M42 Junction 6 Development Consent Order

8.71 Supplementary Environmental Appraisal Report on the proposed non-material changes

Supplementary Environmental Appraisal Report on the proposed non-material changes

Regulation Number	Rule 8(1)(k)
Planning Inspectorate Scheme Reference	TR010027
Document Reference	8.71
Author	M42 Junction 6 Project Team & Highways England

Drawing Title
WORKS PLANS
REGULATION 5(2)(J)
SHEET 3 OF 7

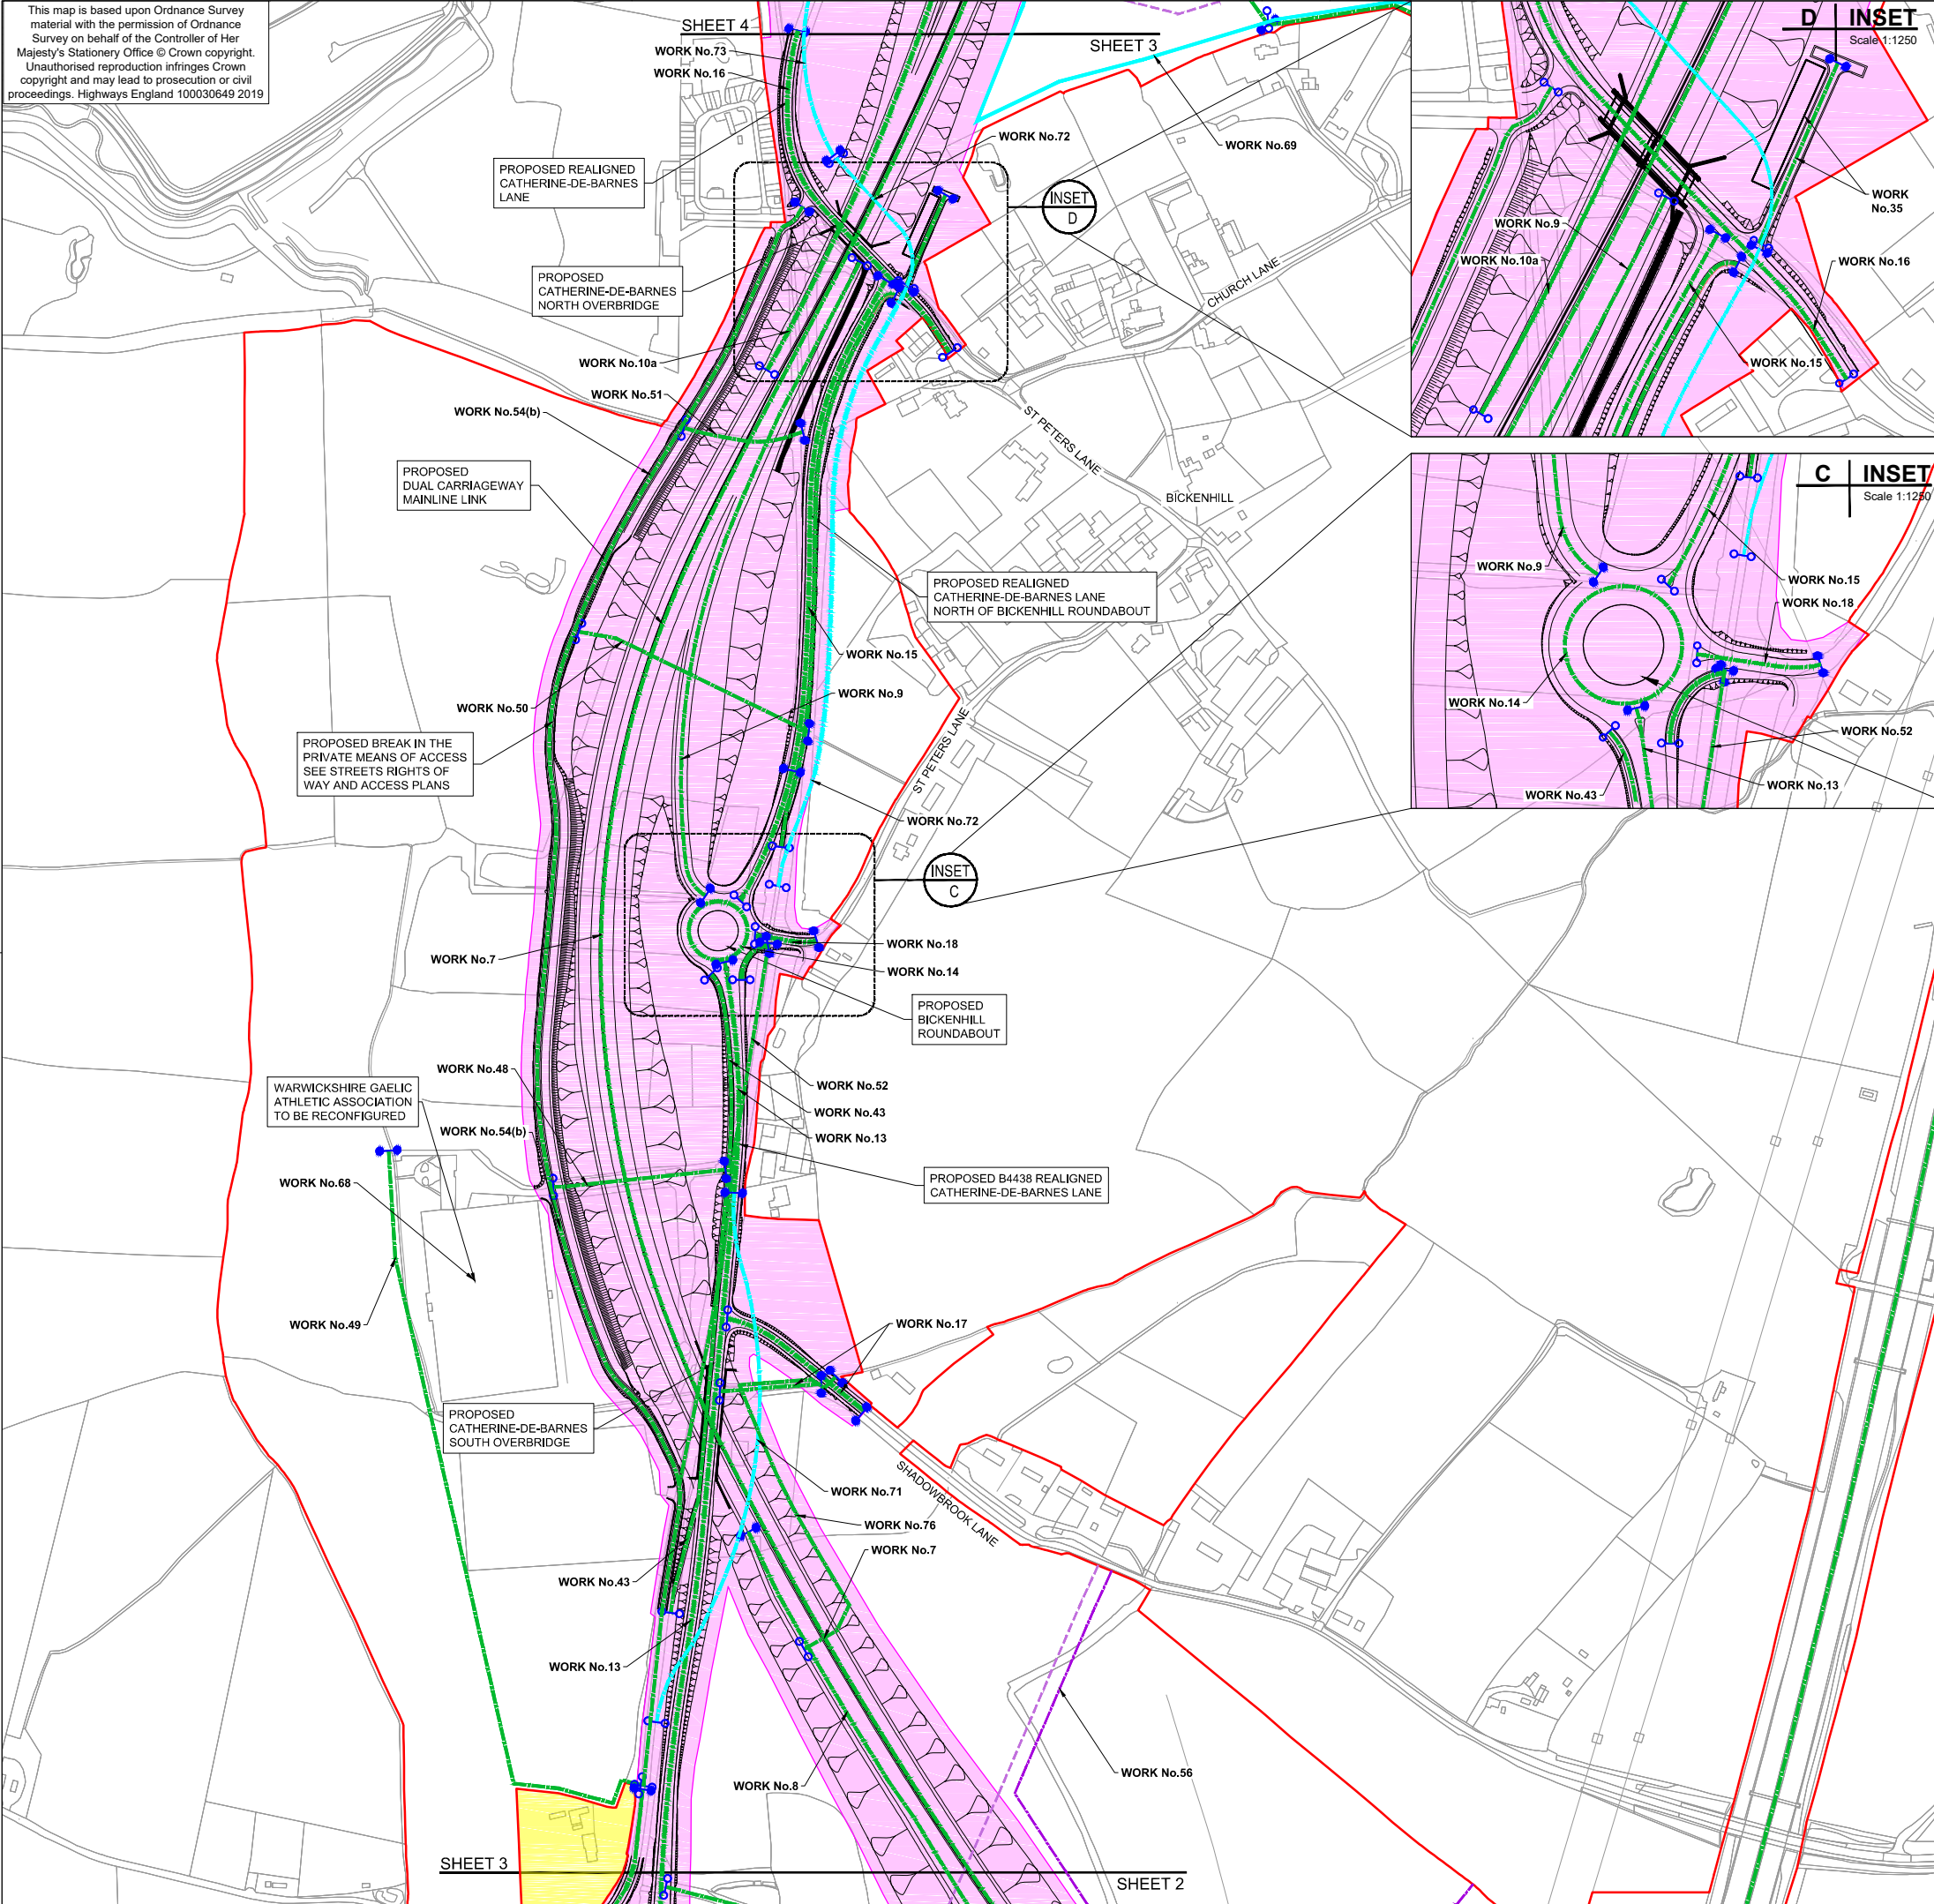
4 Change 1: Proposed change to the southern extent of the LoD for Work No. 63 (Severn Trent Aqueduct)

- 4.1.1 Design information provided by Severn Trent Water (see Appendix A) shows that its preferred route for the aqueduct diversion (Work No. 63) would be further south than that envisaged in the Scheme to allow greater ease of maintenance once the Scheme is operational.
- 4.1.2 This would necessitate the southern extent of the Limit of Deviation (LoD) for Work No. 63 (see Appendix B) to move further south from parcel 4/4w, into parcel 4/4k (see Appendix C). Both parcels have the same landowner. Parcel 4/4k is already proposed to be used temporarily for the diversion of Western Power Distribution's apparatus, with permanent rights being sought under the DCO "*to construct, operate, access and maintain diversions to existing utilities apparatus and equipment*" [APP-018/Volume 4.1].
- 4.1.3 This proposal would not require additional land take beyond the existing Order limits.

First Issue	WC	05/08/19	P01
Update to Work No.63 Limits of Deviation	JCH	07/08/19	P02
Revision Details	By	Date	Suffix
	Check

Drawing Title
WORKS PLANS
REGULATION 5(2)(J)
SHEET 4 OF 7

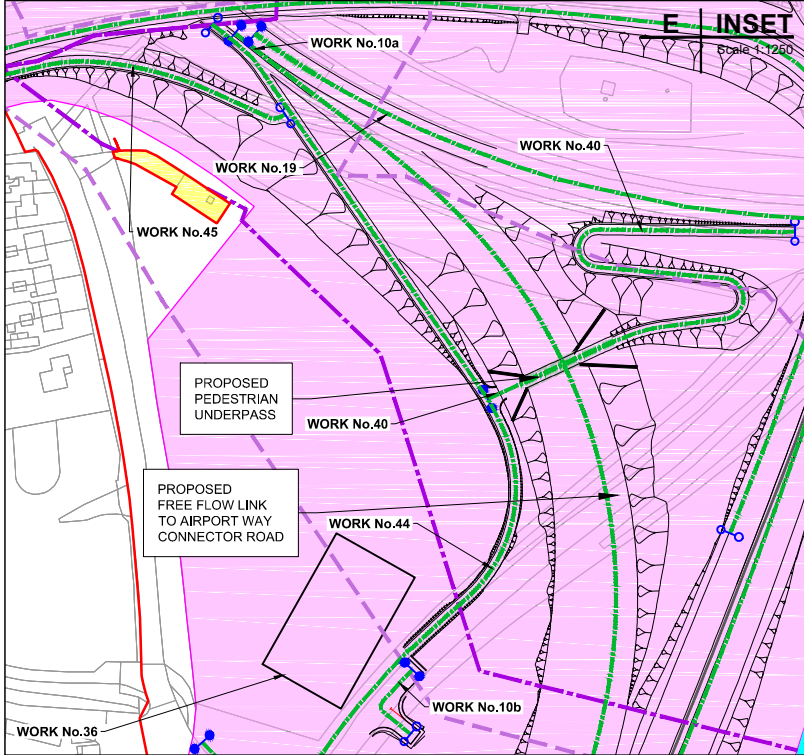
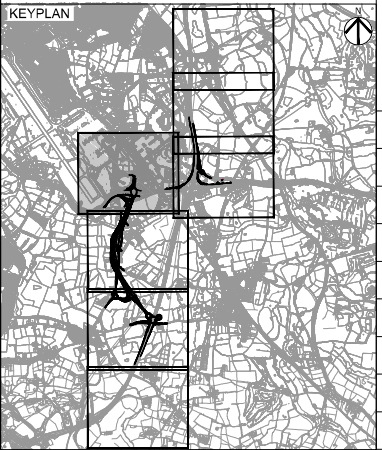
First Issue	WC	05/08/19	P01
Update to Work No.63 Limits of Deviation	JCH	07/08/19	P02
Revision Details	By	Date	Suffix
	Check
